**COUNTRYSIDE PROPERTIES
CLAY FARM, CAMBRIDGE
PRIMARY ROUTE SURFACE FINISHES
CHICANE 2 AT GREEN LINK**

PLANNING APPLICATION

06_4074_SK42 PL3

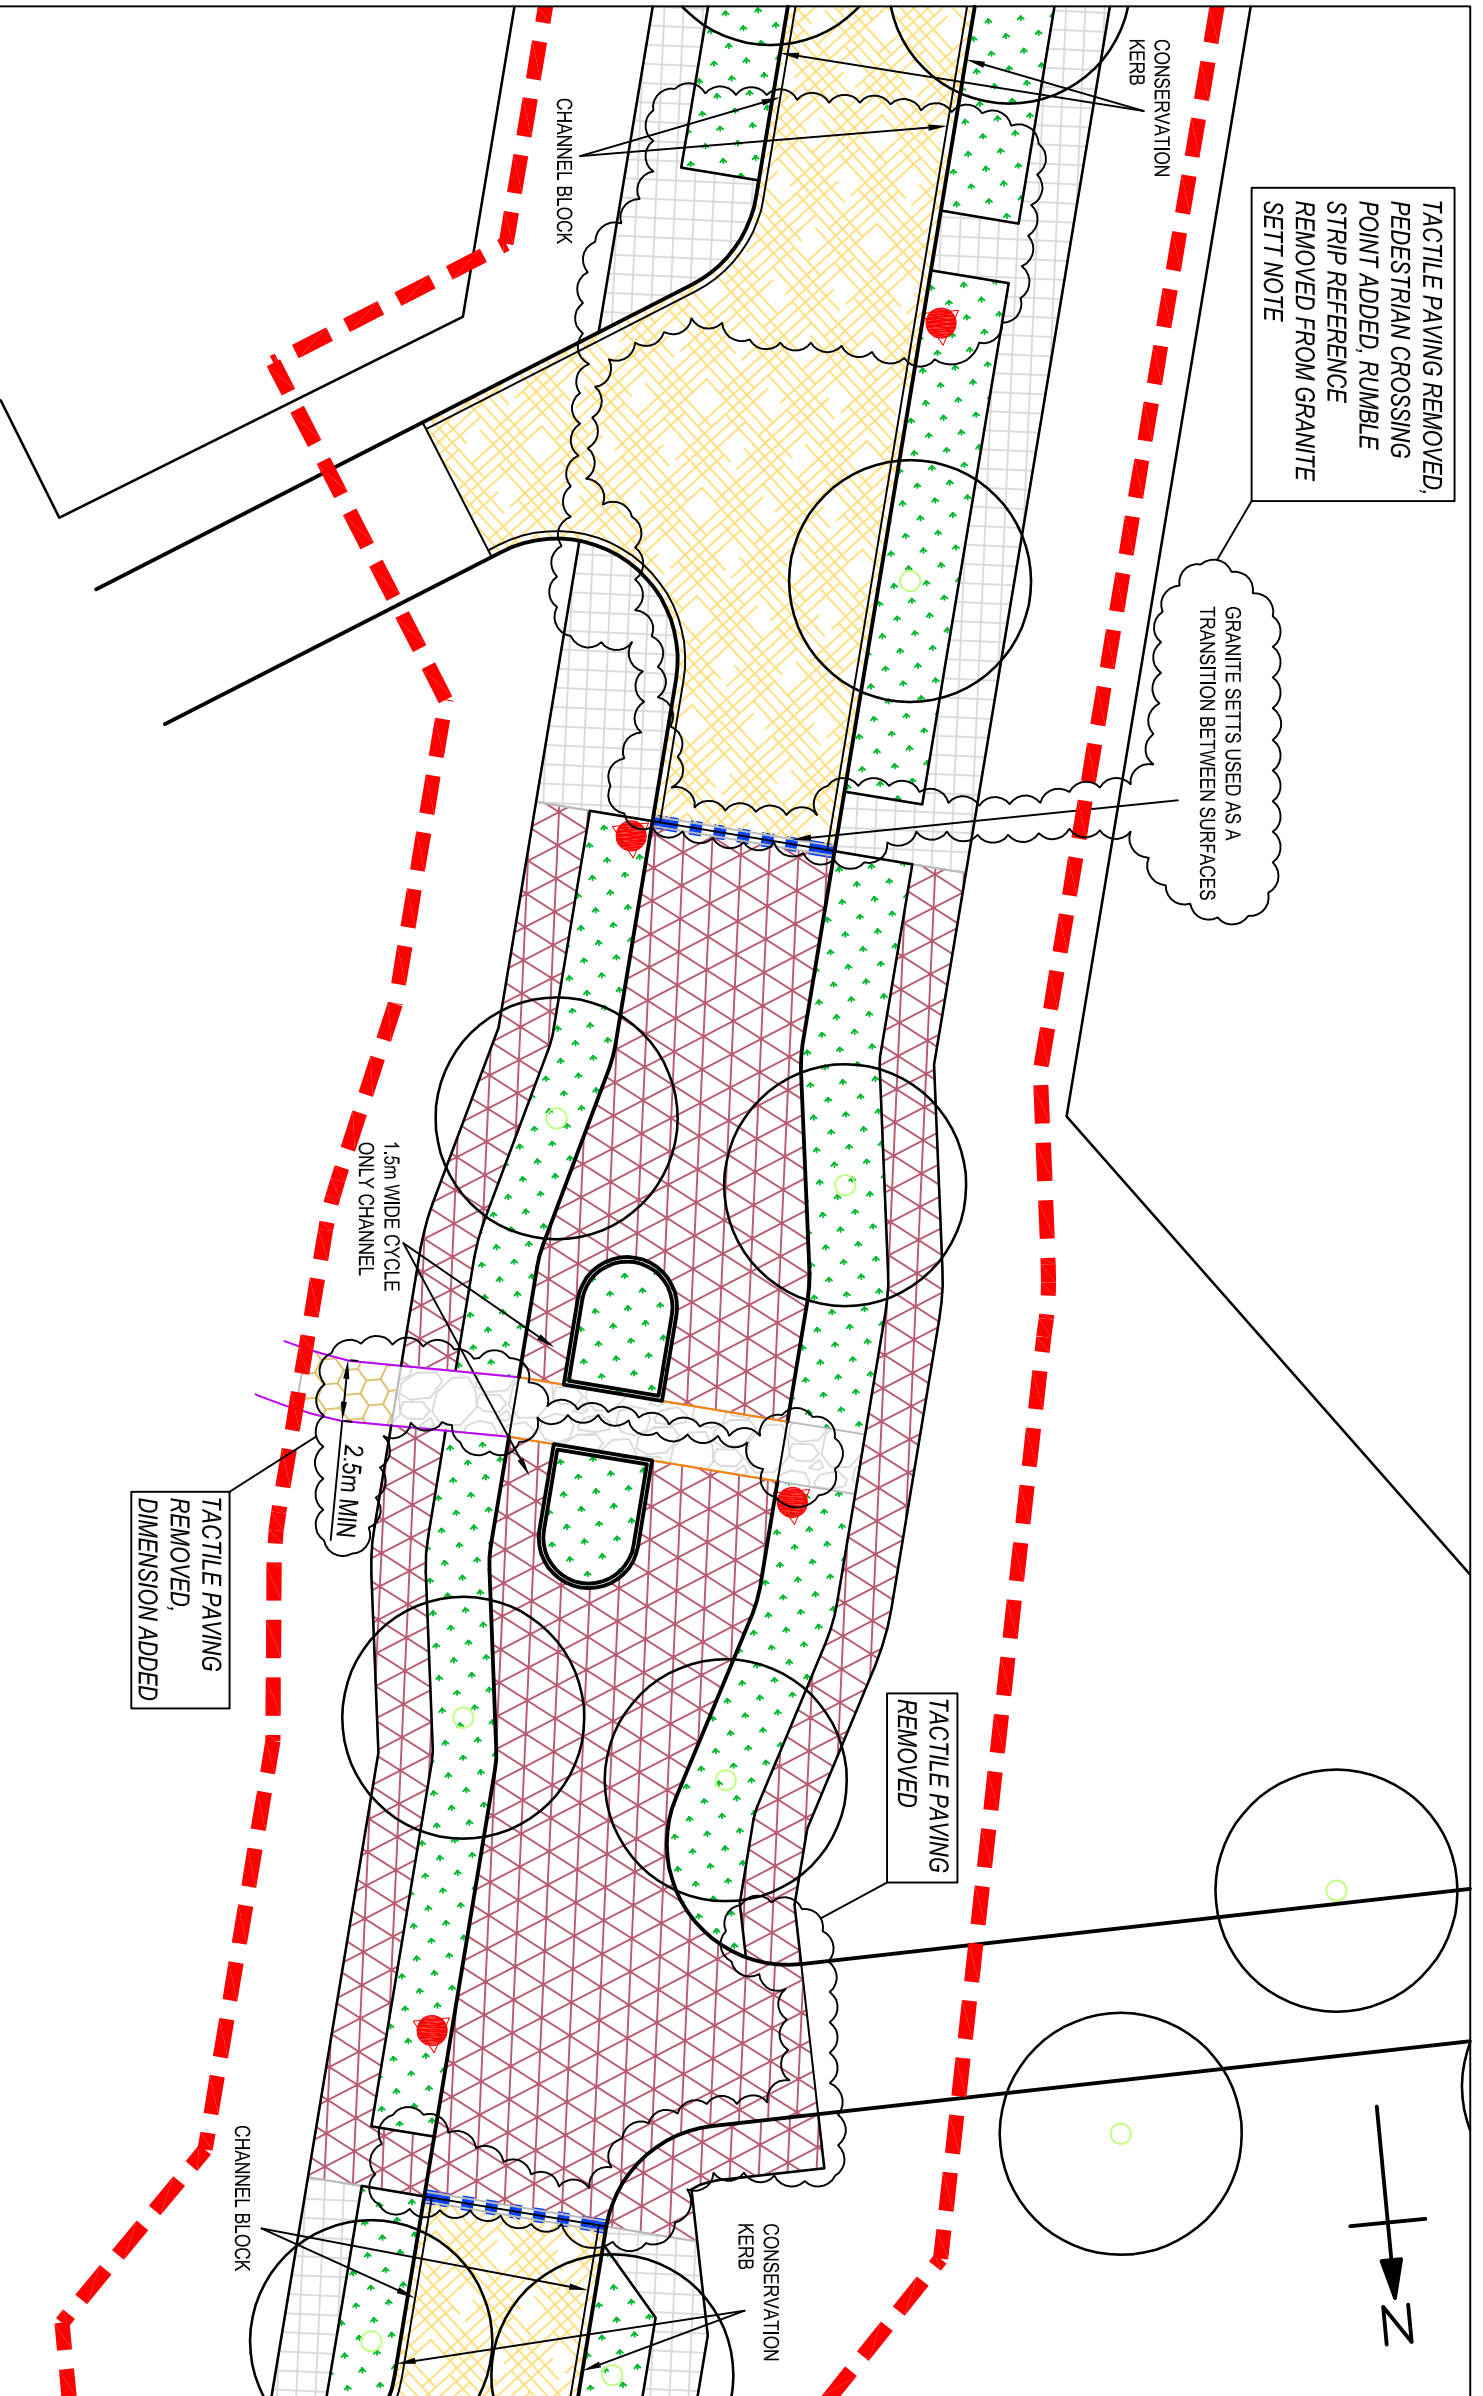
TACTILE PAVING REMOVED,
PEDESTRIAN CROSSING
POINT ADDED, RUMBLE
STRIP REFERENCE
REMOVED FROM GRANITE
SETT NOTE

TACTILE PAVING
REMOVED,
DIMENSION ADDED

TACTILE PAVING
REMOVED

REVISIONS FOLLOWING PLANNING / HIGHWAY COMMENTS AS ANNOTATED	AMRP	18.11.09.	PL3
REVISIONS FOLLOWING PLANNING / HIGHWAY COMMENTS	AMRP	29.10.09.	PL2
PLANNING APPLICATION ISSUE	AMRP	20.03.09.	PL1
